**City of Portland, Maine – Building or Use Permit Application** 389 Congress Street, 04101, Tel: (207) 874-8703, FAX: 874-8716

Location of Construction: 61 Olympia St		Owner: Morse, Robin		Phone: 874-8012		Permit No: 971259	
Owner Address:		Lessee/Buyer's Name:		Phone:		BusinessName:	
Contractor Name: Michael R. Pock		Address: 86 Grand St So. Portland, ME 04106		Phone: 799-5462		Permit Issued: <b>PERMIT ISSUED</b> NOV 19 1997 CITY OF PORTLAND Zone: CBL	
Past Use: 1-fam		Proposed Use: Same		COST OF WORK: \$ 32,000.00 FIRE DEPT. <input type="checkbox"/> Approved <input type="checkbox"/> Denied Signature:		PERMIT FEE: \$ 180.00 INSPECTION: Use Group: Type: 000896 Signature:	
Proposed Project Description: Construct Double Dormers 2 <sup>nd</sup> Floor				PEDESTRIAN ACTIVITIES DISTRICT (P.A.D.) Action: <input type="checkbox"/> Approved <input type="checkbox"/> Approved with Conditions <input type="checkbox"/> Denied Signature: Date:		Zoning Approval: <b>Special Zone or Reviews:</b> <input type="checkbox"/> Shoreland <input type="checkbox"/> Wetland <input type="checkbox"/> Flood Zone <input type="checkbox"/> Subdivision <input type="checkbox"/> Site Plan maj <input type="checkbox"/> m

3RD FLOOR PLAN  
SCALE 1/4" = 1'-0"

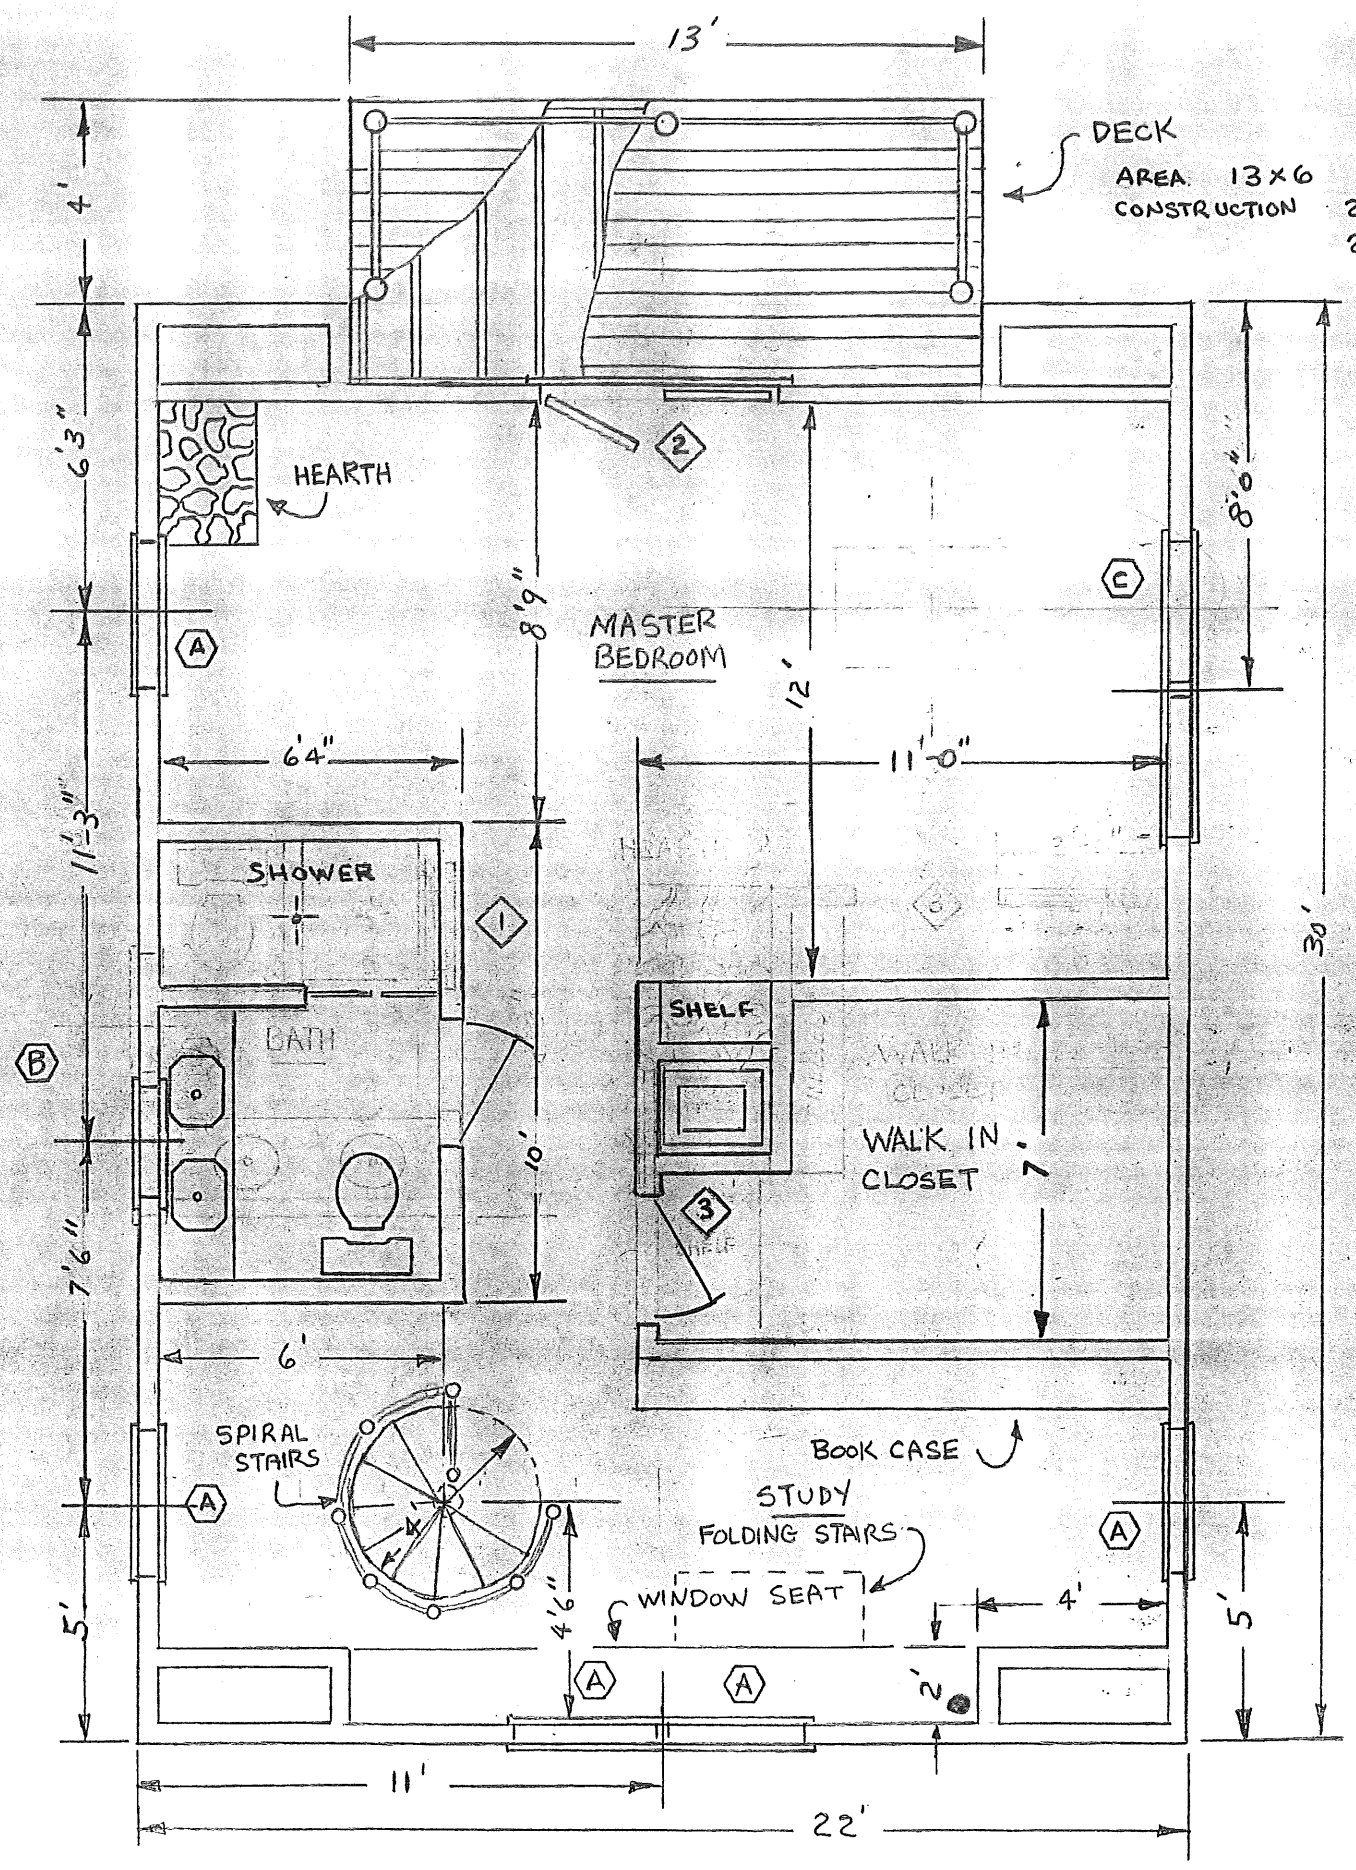
3/22/99 For Final - Plumbing OK - Carpentry OK Except for Spiral Stairs - Ballistics exceed 4" - open Recesses 8 1/2 -

9" rise, no Guard Rails on top landing - Owner was aware of this & is designing final work (16)

- X 31. The proposed spiral stair, must meet the requirement of section 1014.6.1.4 of the City's Bld. Code. (The BOCA National Building Code 1997). Please see attached.
